**CASTLE
GATE**
COAL COMPANY

Re: Nationwide Permit for Minor Road
Crossing
30 CFR 330.5(14)

ATTACHMENT NO. 1
Ten Pages and
Aerial Photo 3.4-1

Culvert Size Determination

Exhibit 3-12 Head for CM pipe culverts flowing full with outlet control $n = 0.024$ (Ref. Hyd. Eng. Cir. No. 5, USBPR, 1965)

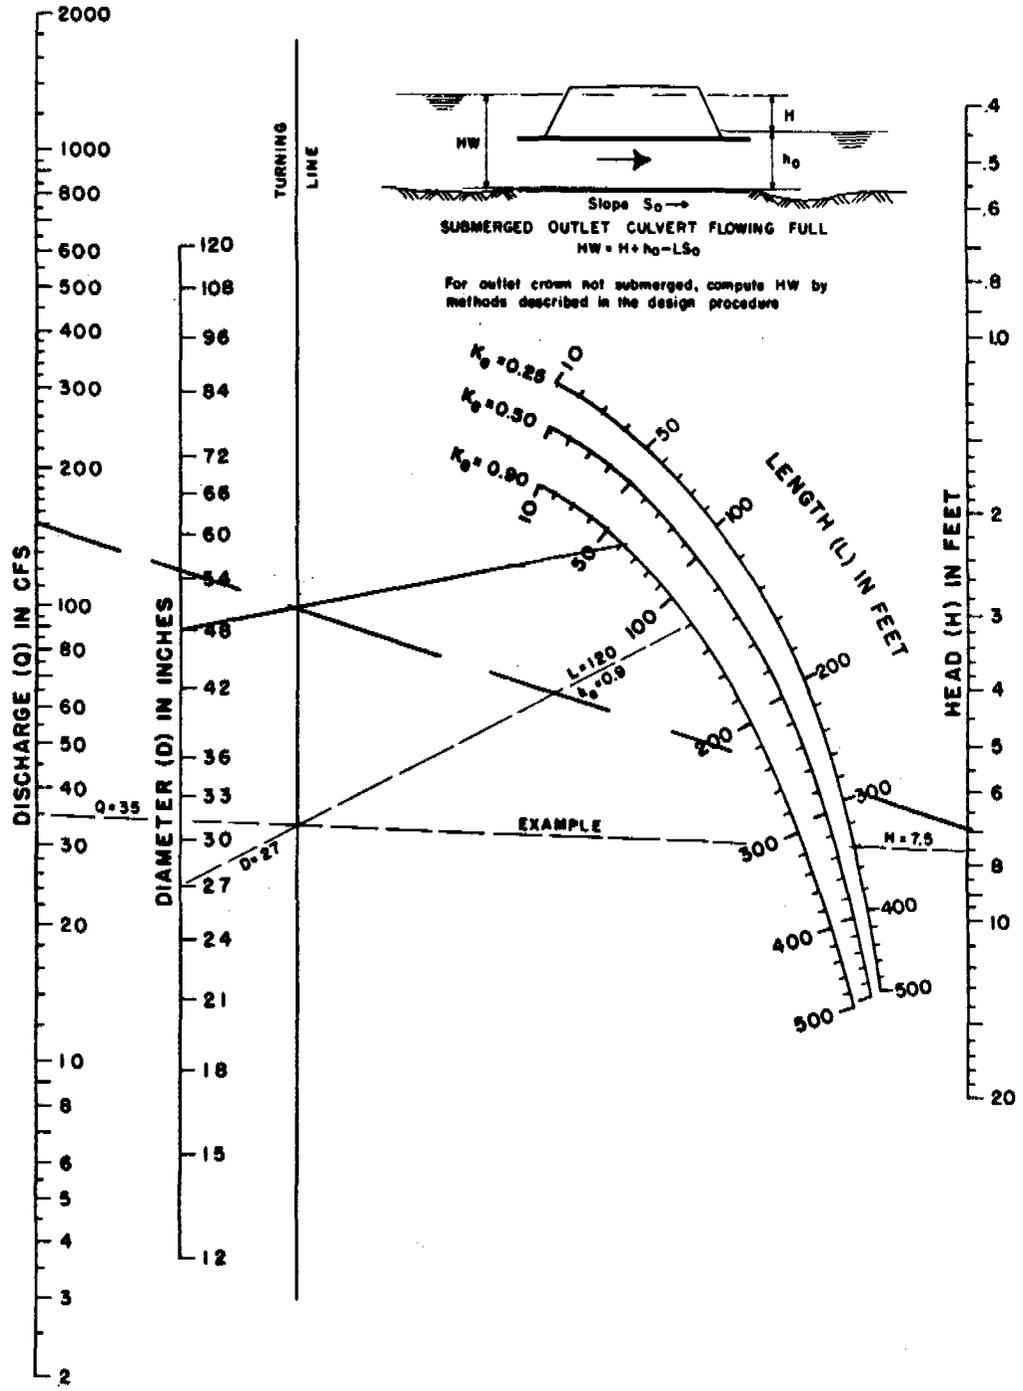
Attached is a copy of the request for a Nationwide Corp Permit. Please notice that I have made the statement that under normal flow conditions of 200 CFS a velocity of 7.2 FPS is expected (Page 8/10 in Corp Submittal Attachment #1). Your letter states that velocity of around 5.2 FPS is needed in order to ensure trout will be able to pass through the structure.

The effect of decreasing the pipe slope to .005 will put the culvert in outlet control and lower the energy grade line. "H" would equal 6.55 feet instead of 7.1' as shown on page 1/10. From Exhibit 3-12 page 6/10 a 60" culvert in outlet control would exceed the 150 cubic feet per second required under maximum anticipated flow.

Therefore, in order to meet the requirements of Wildlife Resources, Castle Gate Coal Company will place one of the middle culverts at .005 ft/ft slope to obtain the flow rate of 5.2 feet per second.

PIPE FLOW CHART
60-INCH DIAMETER

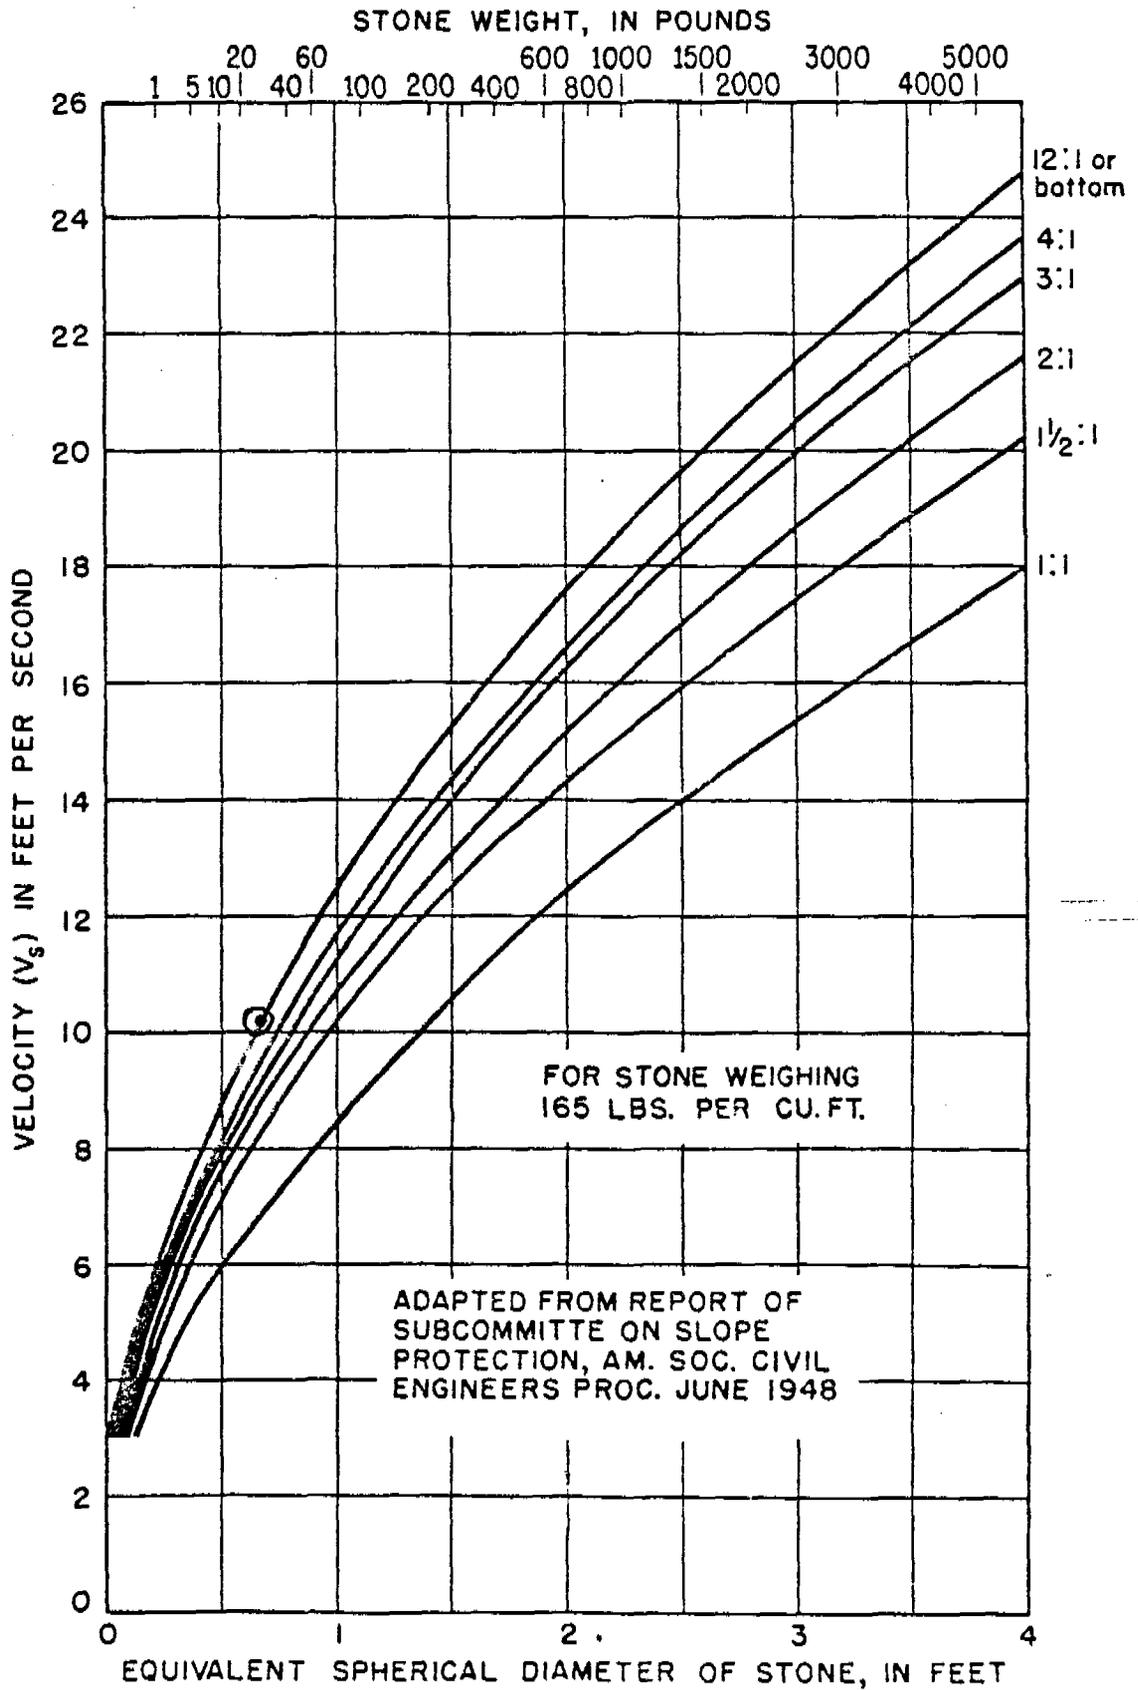
In order to lower the velocity, the slope of one of the culverts must be lowered. From chart 47 page 8/10 of the Corp Submittal 50 CFS and .005 slope will yield a velocity of less than 5.5 feet per second.
